Review: Assessing fragility of a reinforced concrete element to snow avalanches using a non-linear mass-spring model
(by P. Favier, D. Bertrand, N. Eckert, I. Ousset, and M. Naaim)

REFEREE #1

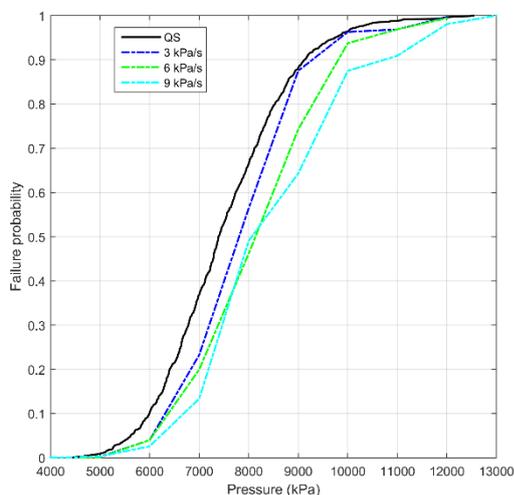
Unlike the civil engineering part, the avalanche engineering part is represented fairly poor in this paper. The RC element is subjected to a quasi-static loading, which does not represent the impact of an avalanche very well.

We agree that, in some cases, inertial effects can occur. For instance, for light and slender structures (such as a mast) located in the heart of the flow, the description of the dynamic response of the structure is mandatory. However, in practice, such a situation is very rare. Second, in a sake of simplicity, in civil engineering design offices, *quasi*-static actions are often assumed to model the avalanche action onto structures. The maximal expected pressure is assessed (based on the flow dynamics) and then an equivalent *quasi*-static pressure is often proposed in order to perform the structure calculation. This are two first reasons why we chose to perform most of our computations under quasi-static conditions.

Most importantly, in our case, we focused on the derivation of fragility curves. The latter are plotted as function of the magnitude of the avalanche (here the maximal pressure reached during the interaction) and explore all the range of failure probability that the structure can reach (from 0 to 1). The question is are dynamic effects of the avalanche on the structure strength significant or can these be neglected? The answer depends on the characteristic times related to the snow flow and to the structural member. Generally, dwellings are located in the runout area where the snow flow loses its kinetic energy. The flow slows down and the pressure fluctuations are less intense. Moreover, the RC walls exposed to the flow are simply supported or fixed to cross-walls which ensure a high stiffness of the RC wall. All these considerations lead to reasonably suppose, in a first approach, that *quasi*-static loading can be assumed for RC constructions located at the end of the flow path.

To enhance our assertion, during the redaction of this article, we explored (not presented in the first article version but added to the new one) the effect of the pressure loading rate onto fragility curves. For the derivation of all the fragility curves presented within the first version of the paper, a loading rate of 0.1 kPa/s was used because it has been assumed that loading rates within runout zones should be much lower than in the middle of the avalanche path. In the new version of the paper, three loading rates (3, 6 and 9 kPa/s) have been considered and the related fragility curves have been built and compared to loading conditions which lead to a *quasi*-static response of the structure. For this specific configuration and for loading rates lower than 3 kPa/s, fragility curves do not exhibit huge differences (see next figure added to the new version of the manuscript – Figure 13).

That said, to comment a little bit more the obtained results related to the influence of the loading rate, in the considered configuration, when the loading rates increase, inertial effects appear and tend to reduce the failure probability of the RC wall. Hence, for this typical loading (triangular loading through time), the inertial effects tend to increase the apparent resistance of the RC wall. However, this result should be used with caution because, based on the way the loading is modelled, higher is the loading rate, smaller is the loading duration. For other pressure time evolutions with longer loading durations, we can expect that the structure would not resist in the same extent and thus the failure probability of the RC wall would be significantly modified (possible increase of the failure probability with the loading rate)
